Informal document GRBP-80-33
(80^h GRBP, 17-20 September 2024,
agenda item 5)

Presentation to support ECE/TRANS/WP.29/GRBP/2024/20

Clarification for UN-R 138.02

Fig. Reverse condition

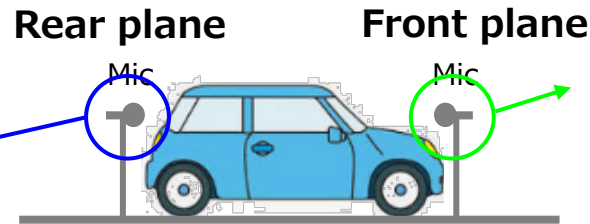
shall not exceed 75dB(A)
 "R" range standstill
 "R" range driving

Regarding when reversing (e.g., position “R”) the maximum sound pressure requirement at the front plane of the vehicle, the current description is not coherent with TF-QRTV which has defined the limit value of 75dB(A) for both stand still and reverse driving. It may cause mis-understanding during type approval.

During measurement in reverse the maximum level requirement ~~in the frontline at the front plane~~ of the vehicle for forward driving ~~has to~~ shall be fulfilled in addition to the requirement at the rear plane. The maximum level requirement at the front plane of the vehicle at standstill condition in reverse shall be equal to the maximum level requirement in motion. This can be stated by manufacturer declaration.

Maximum	Reverse	
	Rear plane	Front plane
Standstill (0km/h)	69dB(A)	75dB(A)
Driving (motion)	75dB(A)	75dB(A)
